Access Compliance Report

Public Rights-of-Way

(Curb Ramps)

Intersection ID: 14468	Main Street: E_TREMONT_AV	Cross Street: EUCLID_AV	Location: E
ADA ID: E4F2DCCC3C19	Ramp Type: PerpDiag	Initial Pass/Fail: Fail	Overall Compliance: No
Severity Score: 25			
Codes/Mitigation Info/Possible Solution		Field Measurements/Component Compliance

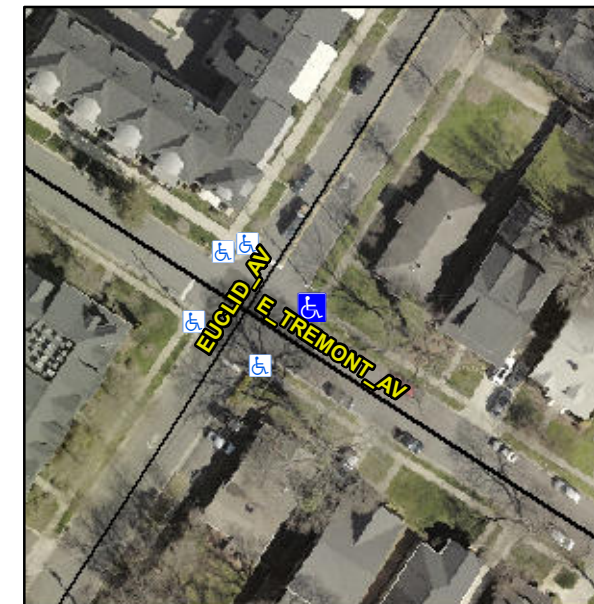
Not Found, R304.2.2

Compliance	Description	Data	Compliance	Description	Data
N/A	Ramp Length (in)	71.0	No	Ramp Slope (%)	13.8
Yes	Ramp Width (in)	48.0	Yes	Ramp XSlope (%)	2.0
N/A	Flare Type LT	N/A	N/A	Flare Type RT	N/A
N/A	Flare Slope LT (%)	N/A	N/A	Flare Slope RT (%)	N/A
N/A	Flare Traversable LT?	N/A	N/A	Flare Traversable RT?	N/A
N/A	Landing Length (in)	N/A	N/A	DWS Provided?	N/A
N/A	Landing Width (in)	N/A	N/A	DWS Contrast?	N/A
N/A	Landing Slope (%)	N/A	N/A	DWS Length (in)	N/A
N/A	Landing X Slope (%)	N/A	N/A	DWS Full Width?	N/A
N/A	Landing Curb? (Y/N)	N/A	N/A	DWS Offset (in)	N/A
N/A	Shared Landing?	N/A			
N/A	Gutter Ponding?	N/A	N/A	Gutter Slope (%)	N/A
N/A	Gutter Lip Ht (in)	1.0	N/A	Gutter X Slope (%)	N/A
N/A	Painted X Walk1?	No	N/A	Painted X Walk2?	No
	X Walk 1 Direction	To NW		X Walk 2 Direction	To SW
N/A	X Walk 1 Width (in)	N/A	N/A	X Walk 2 Width (in)	N/A
	X Walk 1 Slope (%)	7.0		X Walk 2 Slope (%)	2.8
	X Walk 1 X Slope (%)	5.5		X Walk 2 X Slope (%)	4.5

Remove & Replace Curb Ramp With Two New Directional Ramps or Equivalent.
